Enclosure 1

DOE Response to Outstanding EPA Concerns for Shielded Containers

The U. S. Environmental Protection Agency (EPA) originally approved the emplacement of shielded container assemblies at the Waste Isolation Pilot Plant (WIPP) with the condition that, "*Prior to shipping shielded containers to WIPP, the U. S. Department of Energy (DOE) must demonstrate a consistent complex-wide procedure to ensure that the shielded containers containing remote-handled (RH) waste remain below the Land Withdrawal Act surface dose rate limit for contact handled (CH) waste of 200 millirem per hour (mrem/hr). The procedure will be evaluated for technical adequacy as part of the Agency's waste characterization inspection and approval process. No shielded containers may be shipped to WIPP from any RH TRU site until the EPA inspects and approves the implemented procedure.*" (EPA letter from J. Edwards to E. Ziemianski dated Aug 8, 2011). The Department of Energy (DOE) responded to this condition by letter from J. Franco to J. Edwards dated May 16, 2013 that included the proposed complex-wide dose rate measurement procedure. The DOE then provided a physical demonstration of the procedure during a

SCA CONTACT DOSE RATE SURVEY AREAS

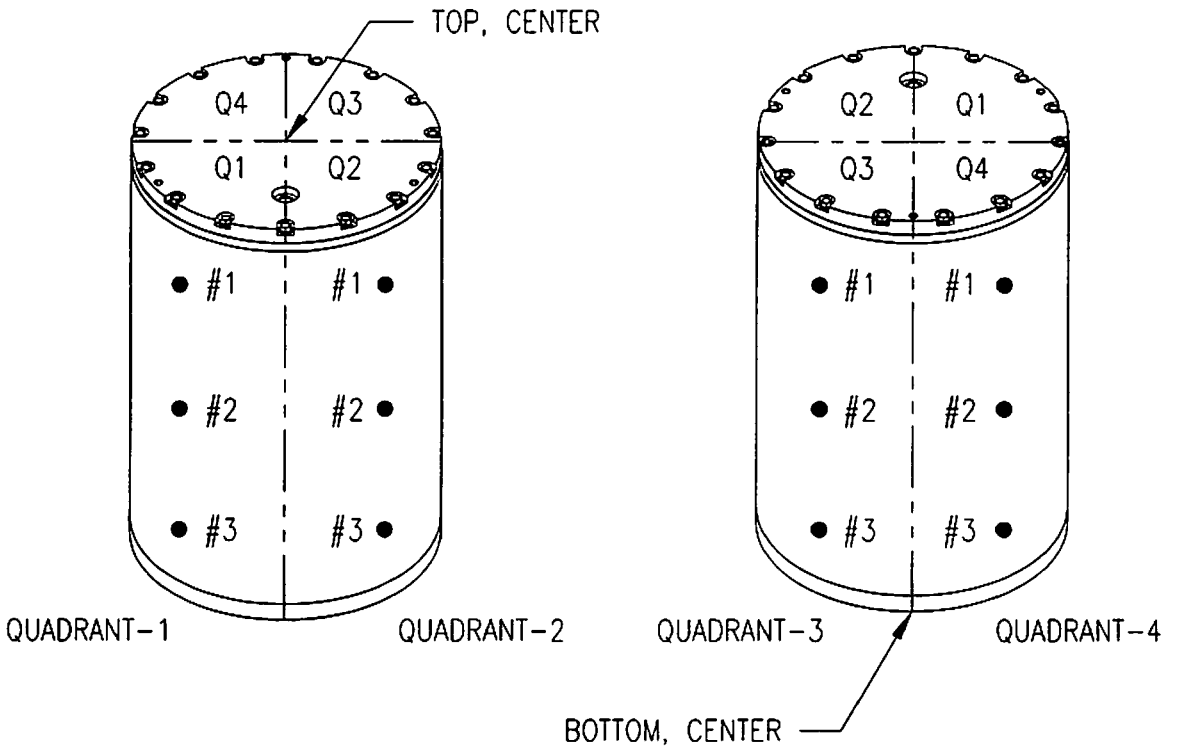
Based on review of the initial dose rate measurement procedure (CCP-TP-081, *Shielded Container Assembly Loading*) provided on May 16, 2013, it was not clear to the EPA how the DOE would ensure that maximum dose rate would be captured on the outside of the shielded container.

The physical demonstration on June 13, 2013 showed that, in practice, dose rate measurements are taken over the entire outer surface of the shielded container. The following discussion provides an in-depth description of how the measurements are conducted. The revised CCP procedure, CCP-TP-081, *Shielded Container Assembly Loading,* is included as Attachment 1.

The surface of the shielded container is divided into 14 sections for surface dose measurement. The cylindrical surface of the container is divided into four quadrants with three sections (top, middle, and bottom) per quadrant, or a total of 12 sections on the cylindrical surface. The top and bottom of the container are two additional sections, for a total of 14 sections. Within each section, the generator site RadCon technician will search for the (local) maximum radiation dose rate and record this value. The maximum of the 14 values for the individual sections is taken as the dose rate of record for the WDS. Procedure CCP-TP-081, *Shielded Container Assembly Loading*, is consistent with this approach. The CCP procedure governing surface dose measurements for the DOE complex will be modified to require the RadCon technician to search for the local maximum within each section. Recent data from measurement of surface dose rates for two shielded container assemblies (SCAs) using the CCP procedure are listed in Table 1.

The cylindrical body of the SCA is divided into four quadrants, each of which is subdivided into three areas as shown on Attachment 2, page 1. The top of the SCA and the bottom of the SCA are two more areas, for a total of fourteen (14) areas on each SCA. Each separate area is completely surveyed, and the highest contact dose rate measurement for each area is recorded on Attachment 2, page 2.

[Q.2] Use the orientation of the filter vent to identify the four quadrants of the SCA cylindrical body (Q1 - Q4). Contact dose rate measurements shall be taken at three areas in each quadrant (e.g., Q1-#1, #2, #3...) and at the top and the bottom of the SCA, such that the entire external surface of each SCA is surveyed.
